Agenda Item **No. 5(f)**
Meeting of July 21, 2026

SUBJECT: Approving a Variation for the Transbay Block 2 West project of the Rooftop Mechanical Screening Development Control required by the Transbay Development Controls and Design Guidelines; Transbay Redevelopment Project Area

Re: Transbay Block 2 West/Philip C. Chin Commons – Request for DCDG Variation Regarding Rooftop Equipment Screening

View on Beale Street looking south

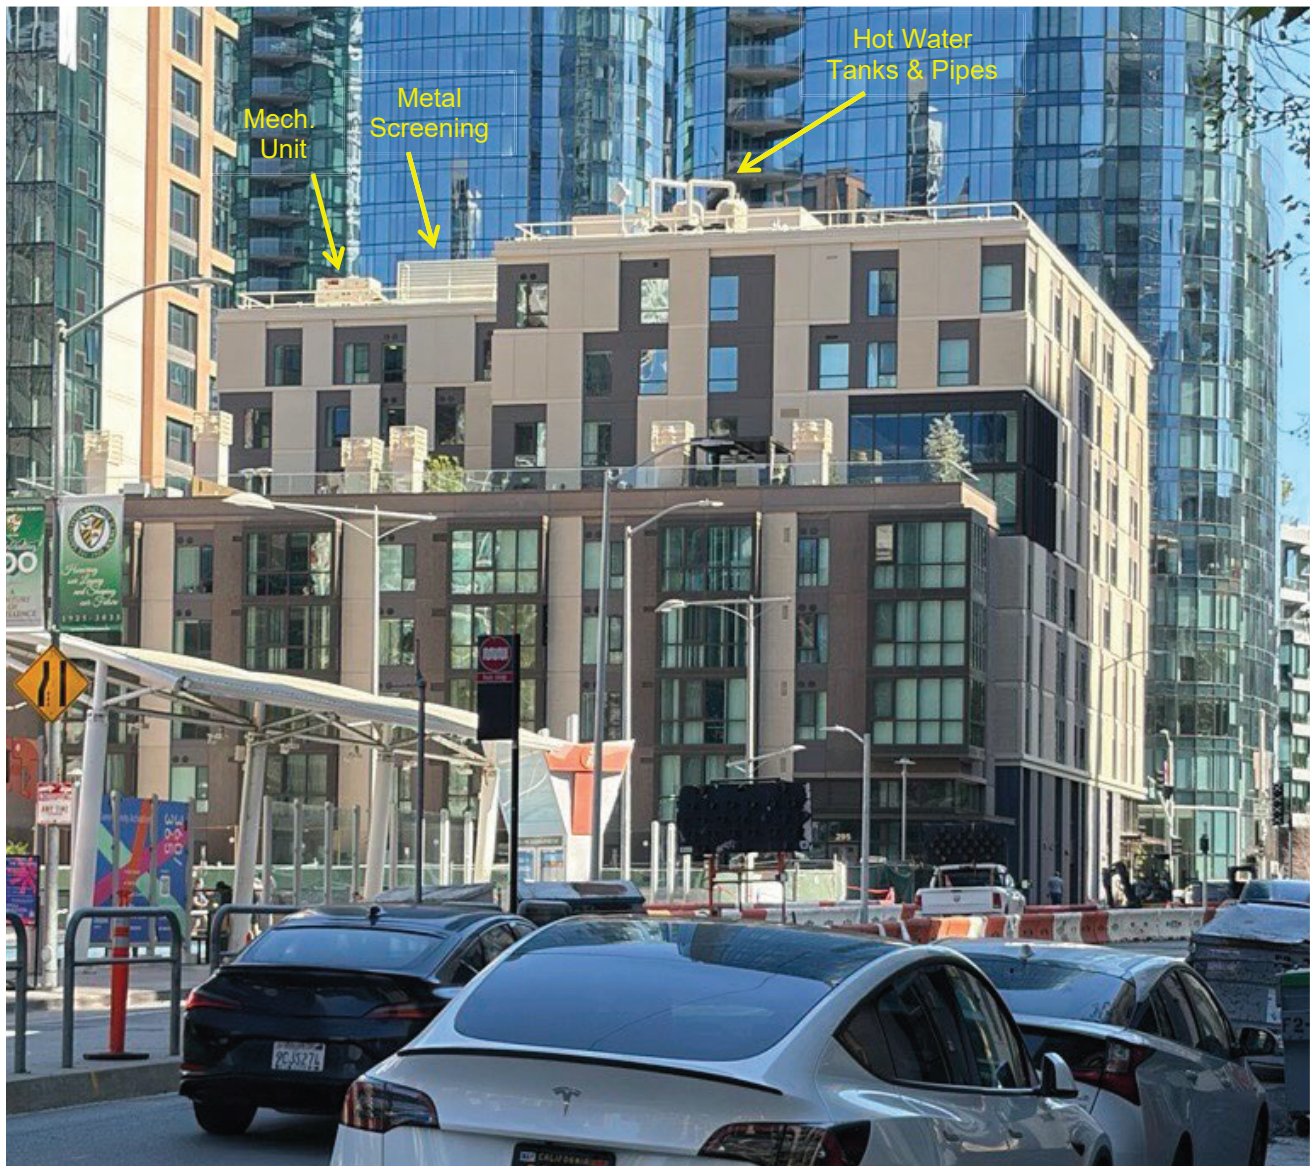
Following construction completion, OCII staff identified that two tall hot water tanks with associated overhead pipes and a mechanical unit located on the roof level 10 are visible from the public realm, contrary to standards in the Development Control and Design Guidelines for the Transbay Redevelopment Project, (the “DCDG”) Development Control No. 5 for Podium and Mid-Rise Buildings (the “Screening Requirement”). As a visual mitigation to the visiblenss of the rooftop equipment, CCDC painted the hot water tanks, pipes and the mechanical unit to match the color of the elevator penthouse behind the tanks.

The water tanks, piping are set 20 feet behind from the roof railing to draw minimal attention, while the focus remains on the architecture design of the low-rise massing facing the public realm. The regular box-shape of the mechanical unit also does not detract from the focus on the low-rise massing. Both mechanical equipment are shielded from the view of same level residential units of the adjacent Lumina Development. Together they do not pose health, safety, or operational concerns. The visibility impact is limited and does not create material detriment to neighbors or the public realm.

OCII staff recommends that the Commission approve the Variation to the DCDG’s rooftop mechanical screening requirement under Podium and Mid-Rise Buildings Development Control Number 5 and therefore as well the removal of the Schematic Design Condition of Approval 14b for Transbay Block 2W.
